S.16 Application No A/NE-LYT/826
Proposed Temporary Private Car Park (Private Car Only)
for a Period of 3 Years in "Residential (Group C)" Zone,
Lot 807 S.E, 827 RP (Part) and 828 RP in D.D 83, Lung Yeuk Tau, Fanling, New Territories

Comments from Transport Department

(see attached drawing 000)

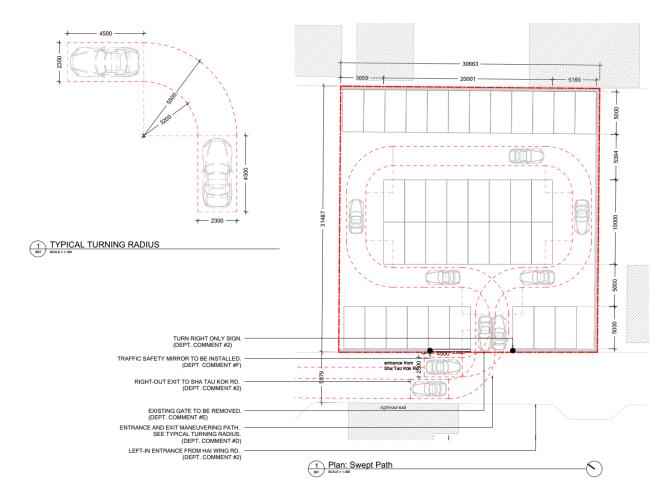
- Inward Traffic: The small number of vehicles entering the car park will likely integrate without significant disruption to the existing traffic flow.
- Outbound Traffic: Vehicles exiting the car park will have a buffer distance to the intersection, facilitating efficient merging.
- 2. To minimize the traffic impact to Hai Wing Road and Dao Yang Road, the applicant should adopt a left-in/right-out arrangement for the entrance of the proposed car park (i.e. ban right-in/left-out movement of vehicles to/from the proposed car park. Relevant traffic management measures should be implemented by the applicant to achieve such arrangement.

Implementation of left-in / right-out arrangement and signage on the proposed car park entrance (see attached drawing 001)

- Inbound Traffic: Vehicles entering the car park will predominantly arrive from Sha Tau Kok Road.
- Outbound Traffic: Vehicles leaving the car park will also predominantly exit onto Sha Tau Kok Road.

Traffic management measures:

- Signage:
 - Install clear signage indicating the allowed movements (right-out) at the entrance and nearby intersections.
- Road Markings:
 - Use road markings to guide drivers and reinforce the traffic management plan.
- Traffic Control Devices:
 - Installation of traffic signals or stop signs if necessary, to facilitate safe entry and exit.
- 3. Please carry out a traffic impact assessment to evaluate the reserve capacities of Sha Tau Kok Road-Lung Yeuk Tau and Dao Yang Road, as well as the design flow/capacity ratio of the junction of Dao Yang Road/Sha Tau Kok Road-Lung Yeuk Tau.
